Re: OPSB Case No. 19-1740-EL-BTA
Application for a First Amendment to the
Scioto Ridge Transmission Line

APPLICATION
TO THE
OHIO POWER SITING BOARD
FOR AMENDMENT TO
CERTIFICATE OF ENVIRONMENTAL COMPATIBILITY & PUBLIC NEED
FOR THE
SCIOTO RIDGE TRANSMISSION LINE
CASE NO. 19-1740-EL-BTA

BEFORE THE OHIO POWER SITING BOARD
First Amendment Application of Hardin Wind LLC
Scioto Ridge Transmission Line

Figure 01-1 Facility Route Revision

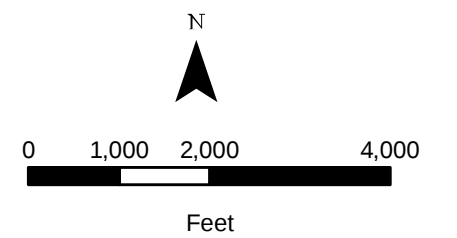
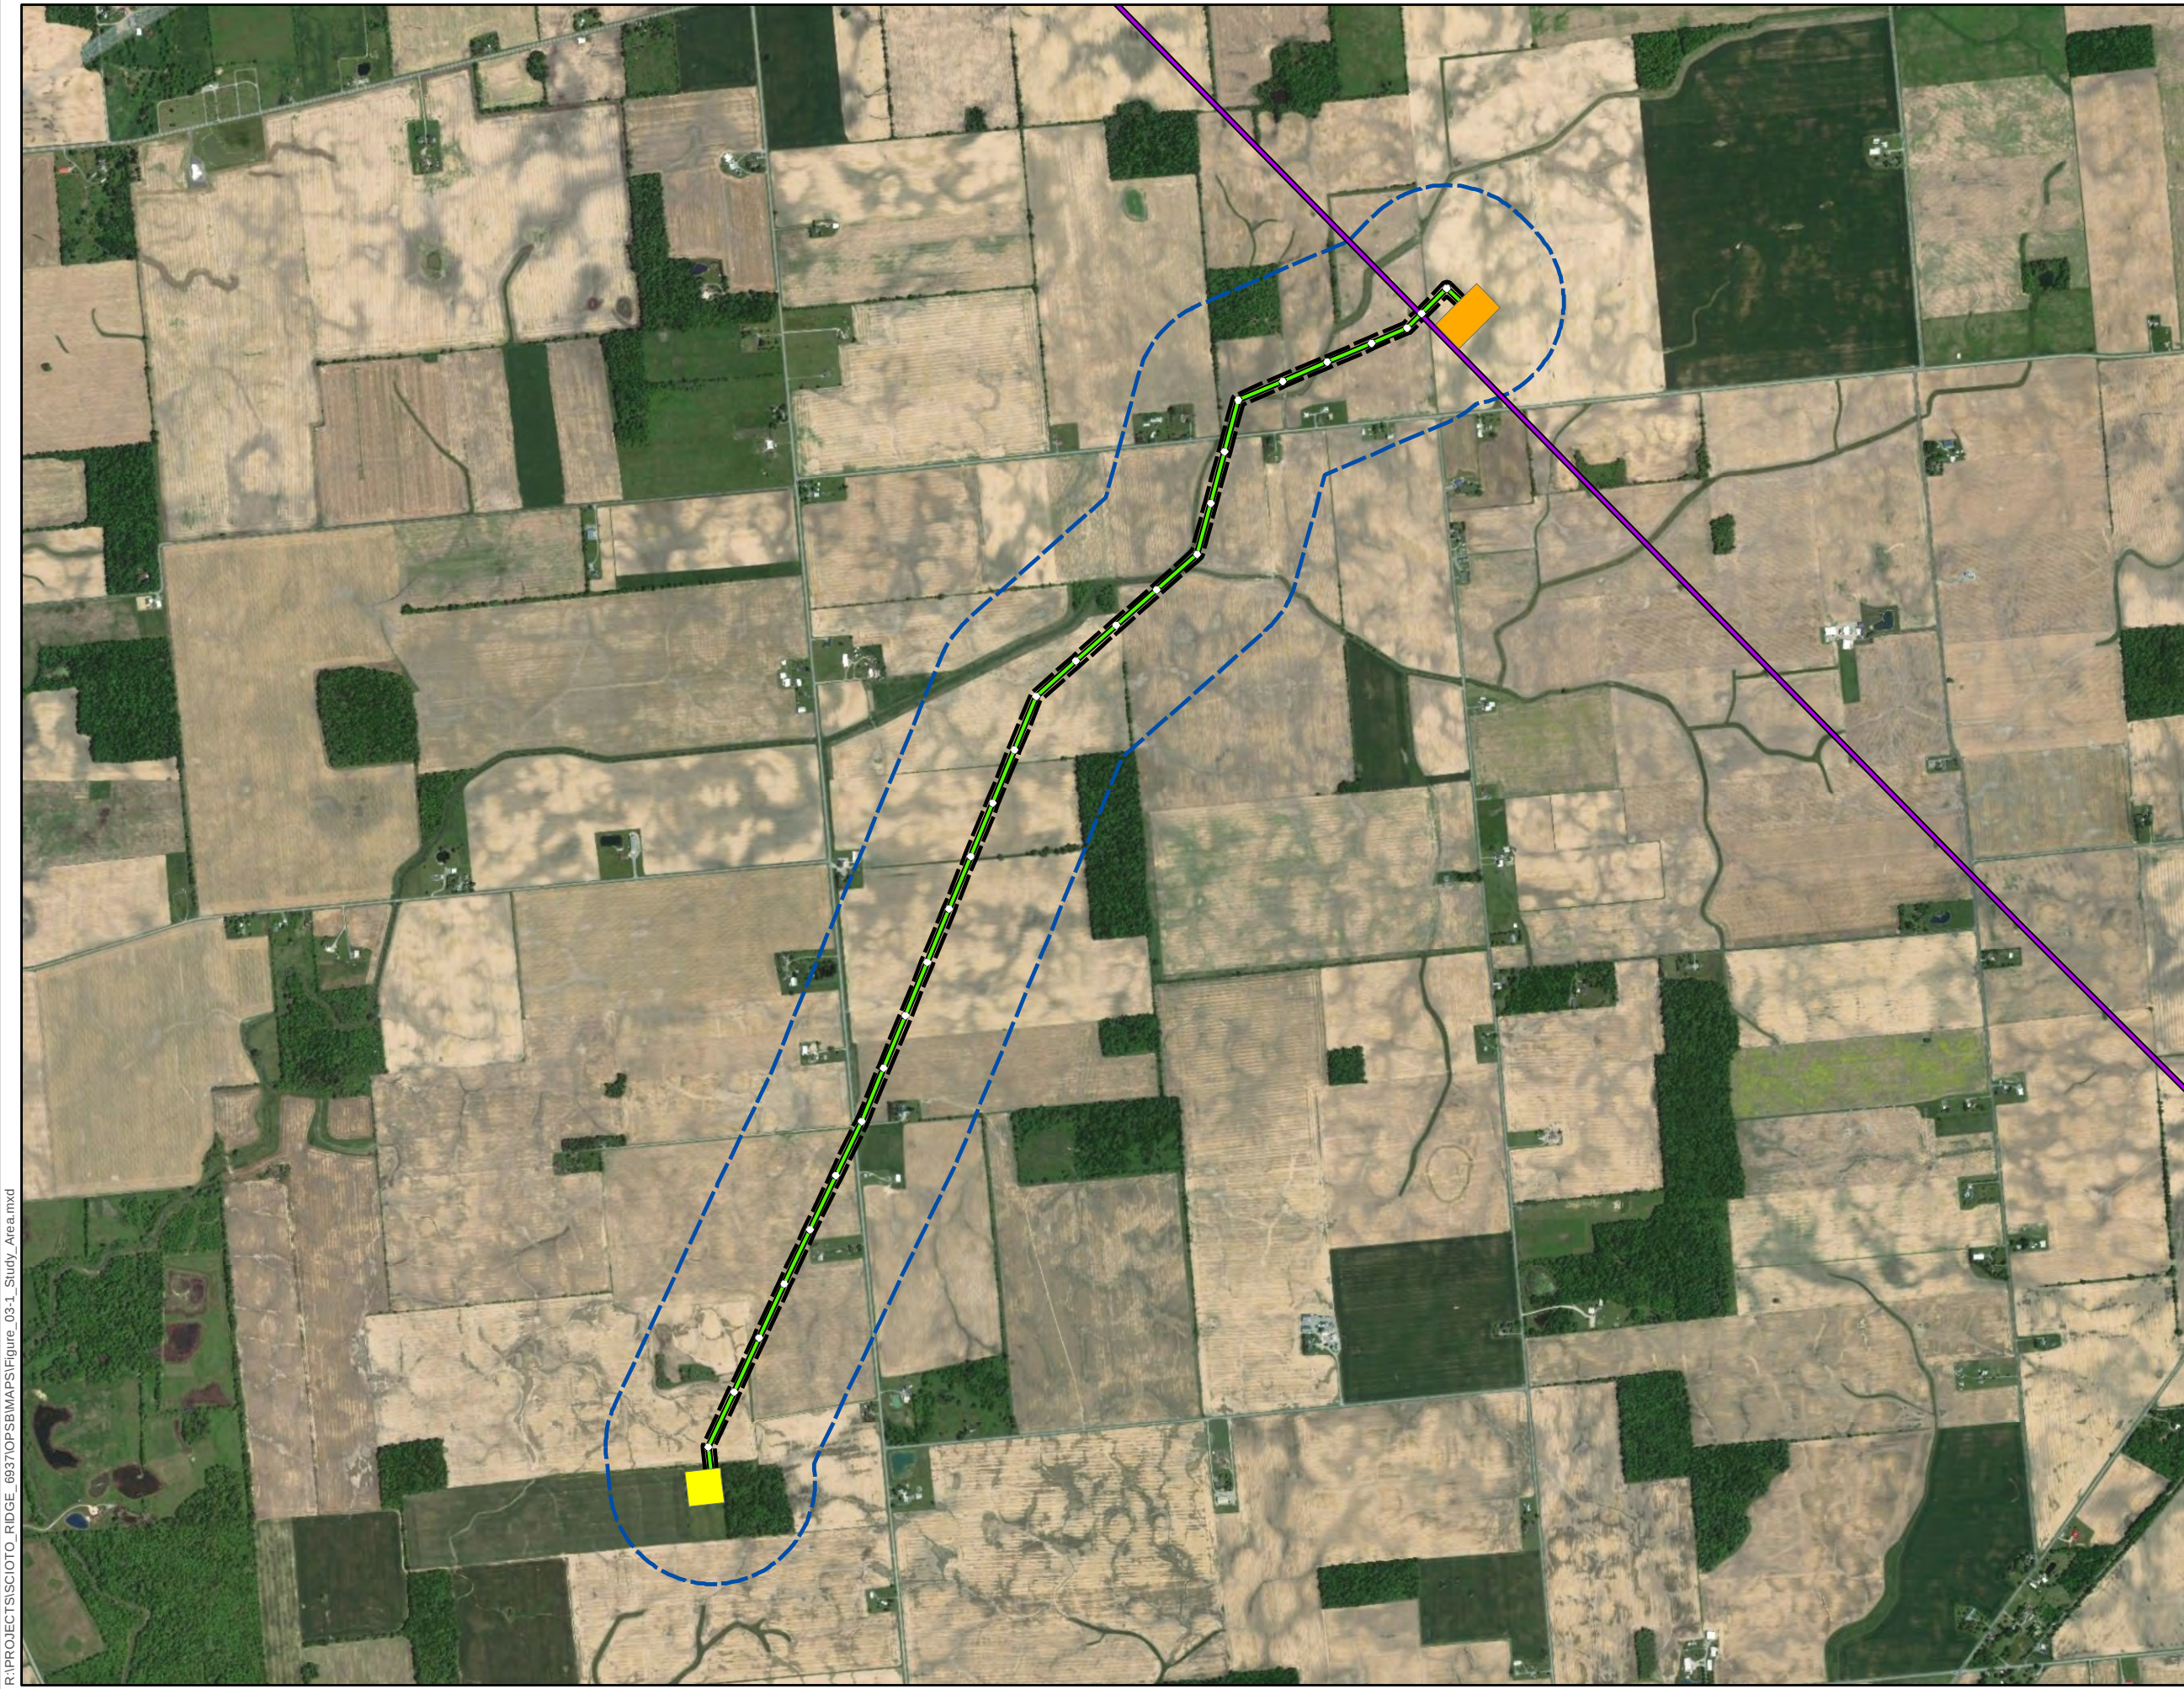
The revised Facility route is approximately 2.9 miles in length, stretching from the Collection Substation, located approximately 0.33 miles west of County Route 75, to the POI Substation, adjacent to and northeast of the existing American Electric Power (AEP) East Lima-Marysville 345-kV Transmission Line. The Facility leaves the Collection Substation at a right angle, traveling north approximately 0.05 miles (Pole 1) before turning north-northeast for approximately 1.6 miles (Poles 2 through 15) and then turning northeast for approximately 0.42 miles (Poles 16 through 19). The revised Facility route then turns north-northeast again for approximately 0.31 miles (Poles 20 through 22) before turning east-northeast for 0.36 miles (Poles 23 through 26). The revised Facility route then angles northeast for 0.11 miles, passing under the

existing AEP 345-kV transmission line, before turning 90 degrees to the southeast for 0.04 miles and entering the POI Substation.

Revised Figure 03-2 Constraints

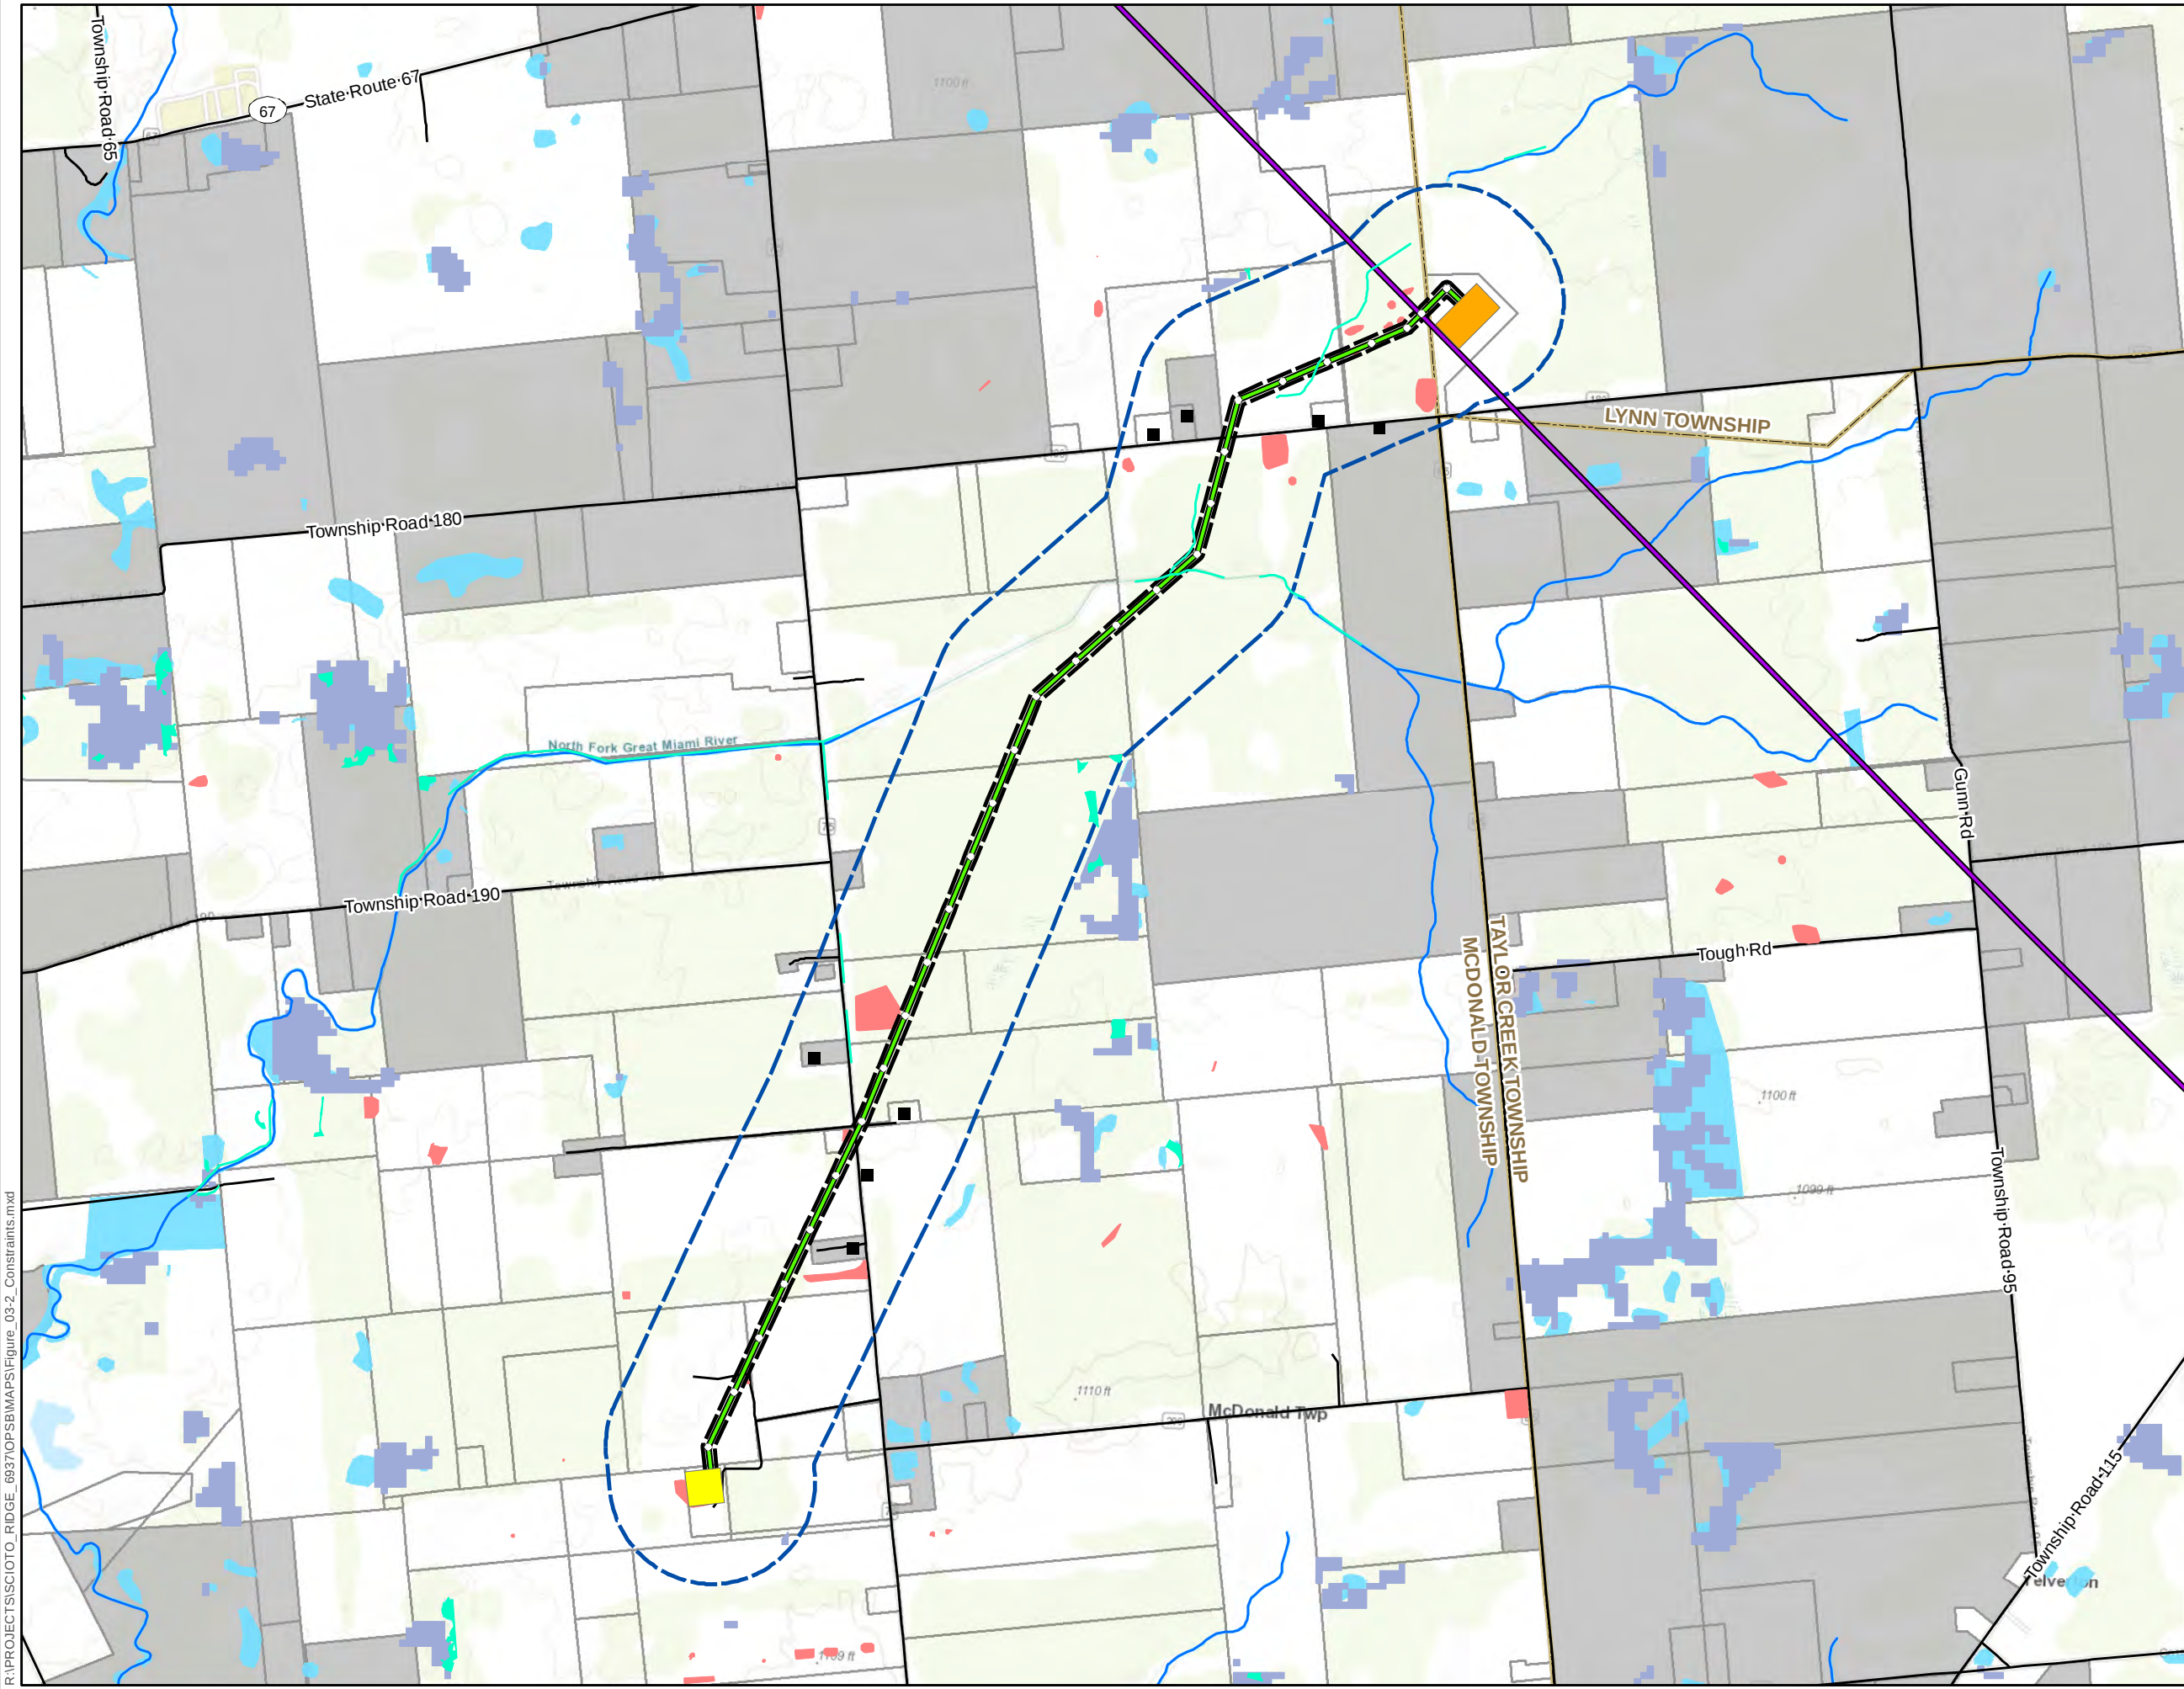
Revised Figure 03-2 depicts constraints used in the route/site selection process.

Revised Figure 04-1 Topography and Slopes

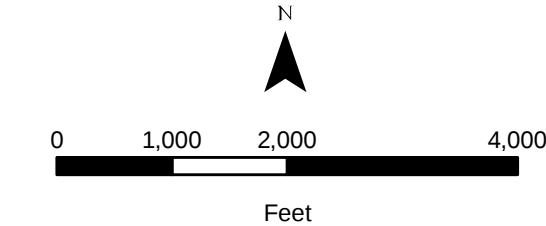
Revised Figure 04-1 depicts the geology and topography at a 1:24,000 scale, and includes all areas in the vicinity of the 1,000-foot study area for the revised Facility route. As shown, geology and topography of the revised Facility ROW and Study Area remain similar to that as presented in prior filings.

Based on topography, and as shown on Revised Figure 04-1, along the 2.9-mile Facility route, slopes exceed 6% for approximately 294 linear feet (approximately 1.9%) of the Facility's

centerline, and no slope within the Facility's 120-foot ROW exceeds 12%. Revised Table 07-5 summarizes the slopes found along the proposed Facility route.
